## Technical Memorandum

**SUBJECT:** Review of Corpora Farms - Mumford Simsboro Aquifer Evaluation Report

**DATE:** September 1, 2023

Figure 1. Proposed Corpora Farms - Mumford Well Location Map

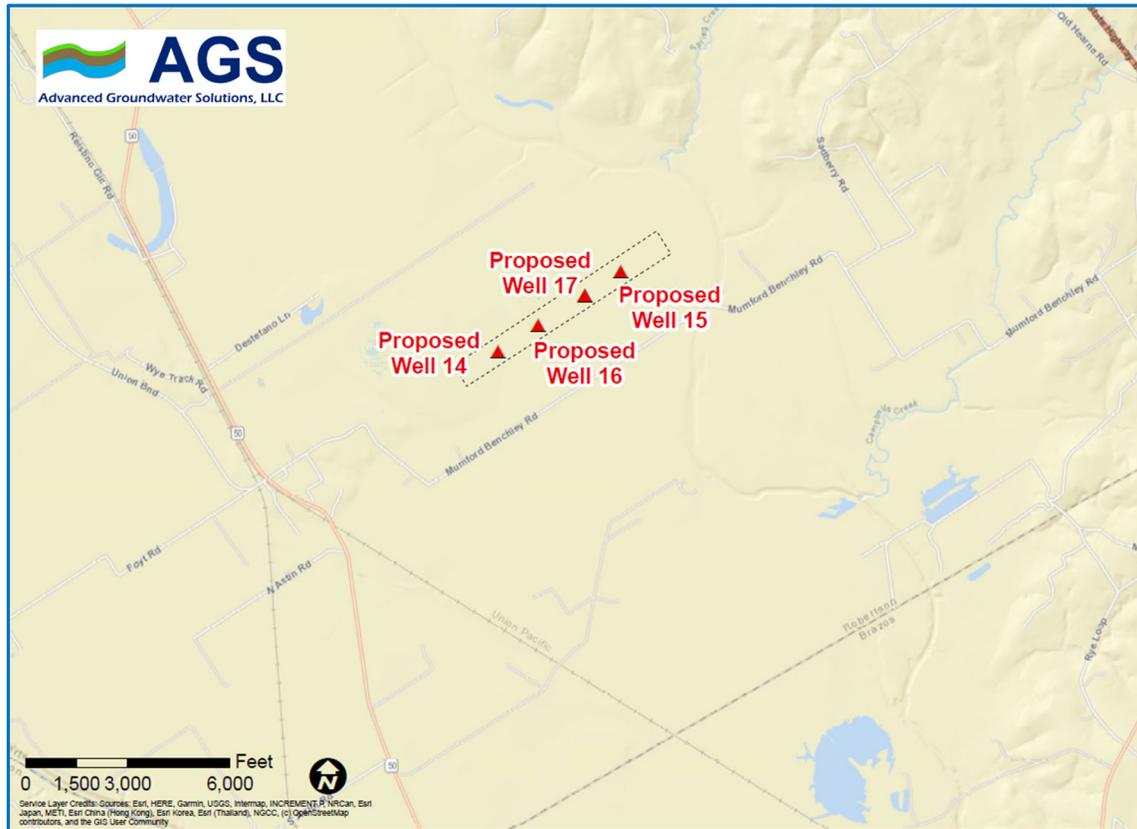
The four proposed Corpora wells each have a maximum production rate of 375 gallons per minute (gpm) and an annual permit allocation of 485 acre-feet. The total annual permit allocation of 1,940 acre-feet requested for the Simsboro Aquifer is slightly greater than the 1,936 acre-feet discussed in the TGI AER. The proposed locations of the four proposed Corpora wells are shown on Figure 1 below.

Figure 2. Projected GMA 12 2021 Planning Cycle DFC Water Level Decline at the Proposed Corpora Farms – Mumford Wells.

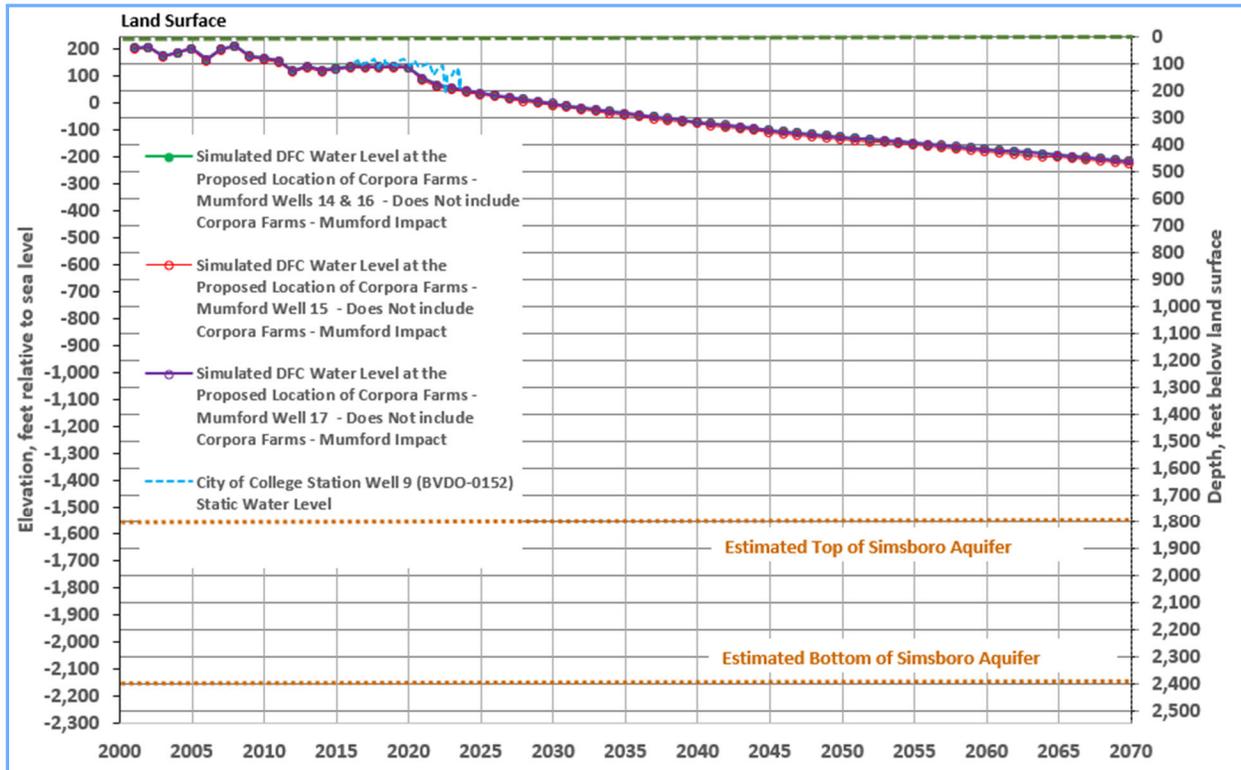
As a way of evaluating potential long-term estimated water level decline at the proposed Corpora wells, AGS plotted the simulated water level decline at each well location based on the 2021 GMA 12 DFC/Modeled Available Groundwater (MAG) projections for the Simsboro Aquifer as shown on Figure 2 below. The water level projections shown in the attached figures are from the TWDB approved DFC/MAG run known as GMA 12 “S-19”, but do not include the local impacts from the proposed CORPORA wells included in the AER, nor do they include all of the pumping from the Simsboro Aquifer that has been permitted in the area in the past year. The DFC run includes pumping estimates from the Groundwater Conservation Districts in GMA 12 as of about December 2021 that yield DFCs so that the TWDB can estimate the MAG. The detailed assumptions for the DFC simulation can be found in the GMA 12 Explanatory Report (Daniel B. Stephens & Associates and others, 2022) and documentation of the TWDB MAG run can be found in GAM Run 21-017 MAG: Modeled Available Groundwater for the Aquifers in Groundwater Management Area 12 (Shi and Harding, 2022).

The graph illustrates the relationship between the land surface, estimated static water level through time and the estimated base of the Simsboro Aquifer based on review of available local electric logs near the locations of the proposed Corpora wells. The simulated DFC water levels through time are very similar for each of the proposed Corpora wells and overlap on Figure 2 above.

Water levels available from the City of College Station Well 9 (BVGCD BVDO-0152) are shown on Figure 2. The well screen sands of the Simsboro Aquifer in the depth interval of about 2,088 to 2,444 feet bgl. BVDO-0152 is located about 2.3 miles southeast of proposed Corpora Well 15.

Available drawdown in wells in the Simsboro Aquifer will decline over time based on the DFC simulation. In other words, the lines with the green, red and purple dots do not include the impact of the proposed Corpora wells. Although not evaluated or discussed in detail herein, these levels of water level decline in wells and artesian head decline in the aquifer will have some impact on vertical leakage, intercepted discharge, reduction in confined and unconfined storage, and potential flow directions in the aquifer. Pumping by the proposed wells will have some of the same type effects on the aquifer.

Figure 7: 1-Year GAM Drawdown Contours

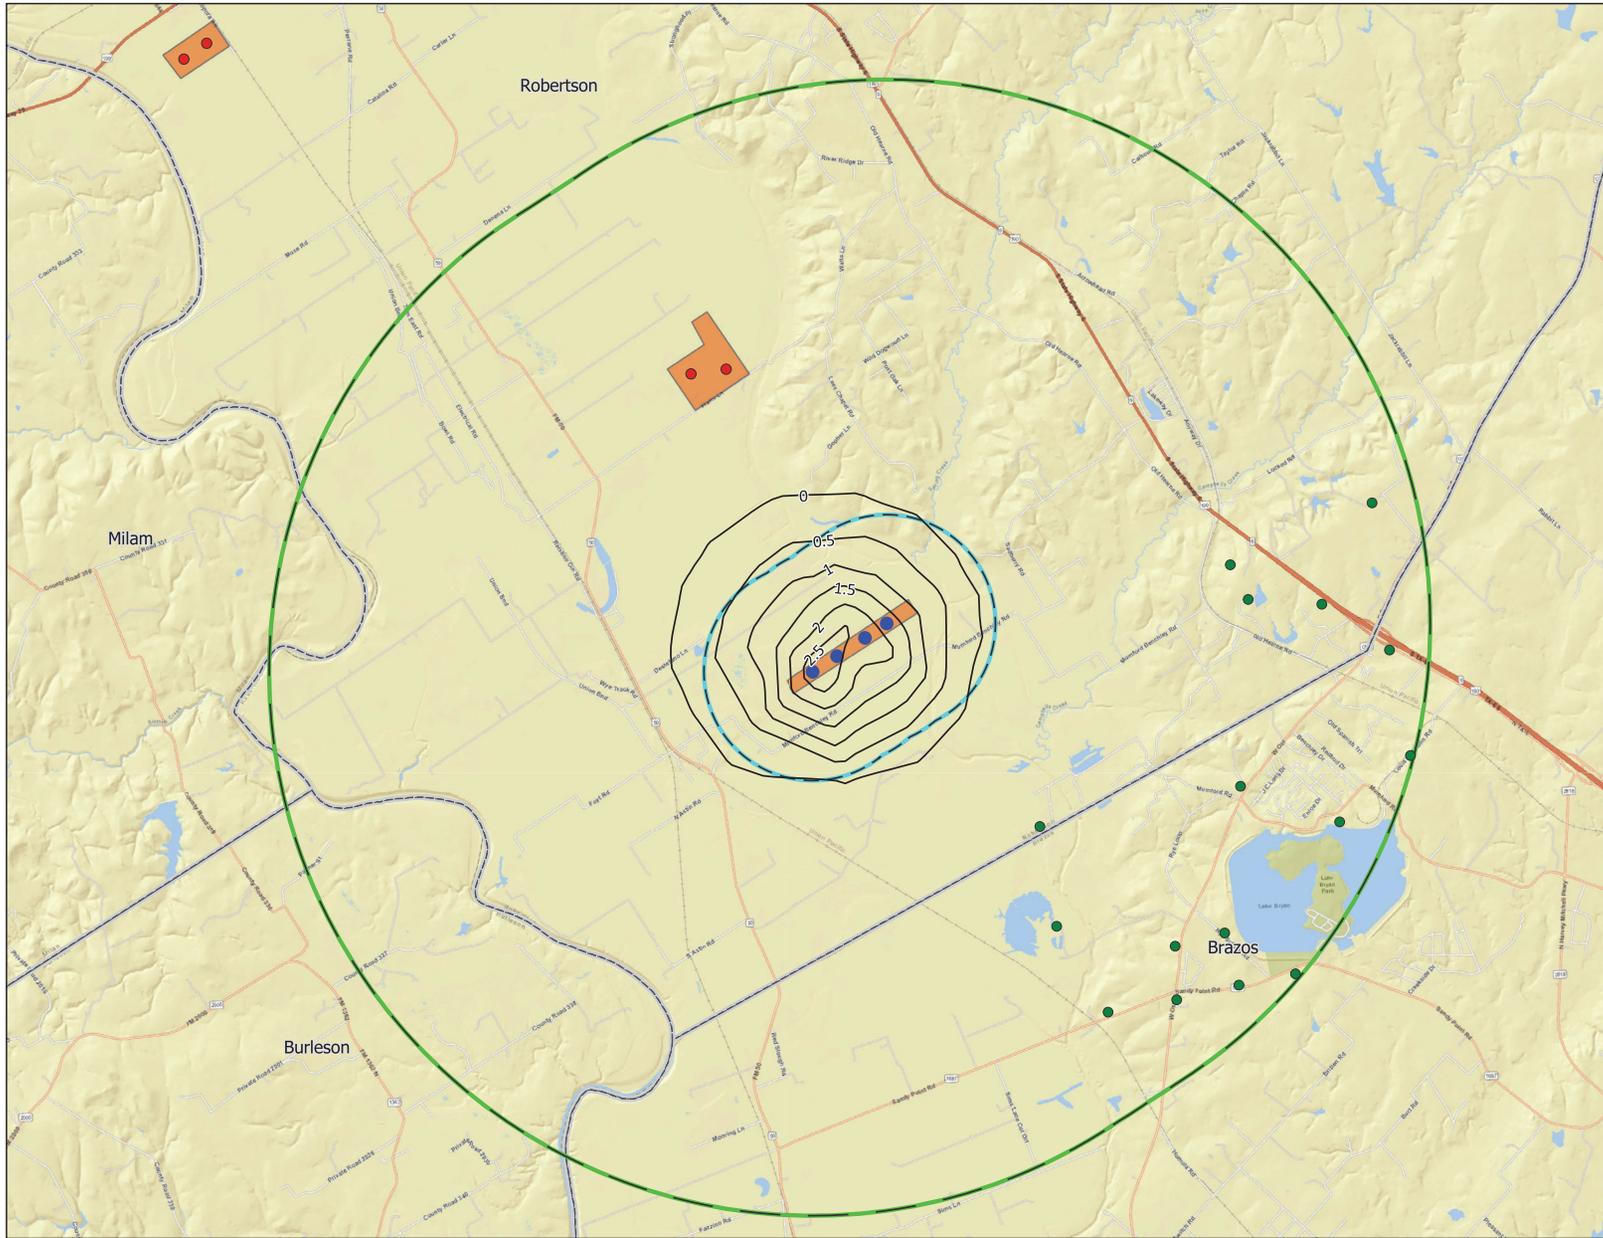
TGI used the TWDB Central Portion of the Sparta, Queen City and Carrizo-Wilcox Aquifer GAM to estimate drawdown that results from continuously pumping the proposed Corpora wells at a combined rate of 1,936 ac-ft/yr for 1-year and 10-years. A copy of the TGI 1-year and 10-year GAM simulated interference drawdown illustrations from the AER (TGI Figures 7 and 8) are attached to this memorandum. Table 1 in the TGI AER shows GAM simulated 1-year and 10-year drawdown estimates at BVGCD permitted and registered Simsboro wells within a 5-mile radius of the proposed Corpora wells. The TGI report did not discuss the GAM simulation methodology, but the TGI GAM model results appear to be reasonable based on AGS simulation verification runs.

The AGS GAM simulation results after 1 and 10 years of pumping 1,940 ac-ft/yr show about 5 to 6 feet of drawdown at 5 miles and about 8 to 9 feet of drawdown at 1 mile after 1-year of pumping and about 7 to 8 feet of drawdown at 5 miles and about 9 to 10 feet of drawdown at 1 mile after 10-years of pumping. The TGI GAM simulations show less drawdown during the 1 and 10-year model simulations than the AGS simulations, but the TGI drawdown estimates are within about 10 feet of the AGS GAM simulated drawdown estimates.

The GAM estimated drawdown contours at distance appear to be influenced by faults included in the GAM, which are in the same general area as faults that have been mapped by GWC and AGS using local geophysical logs and other hydrogeologic data.
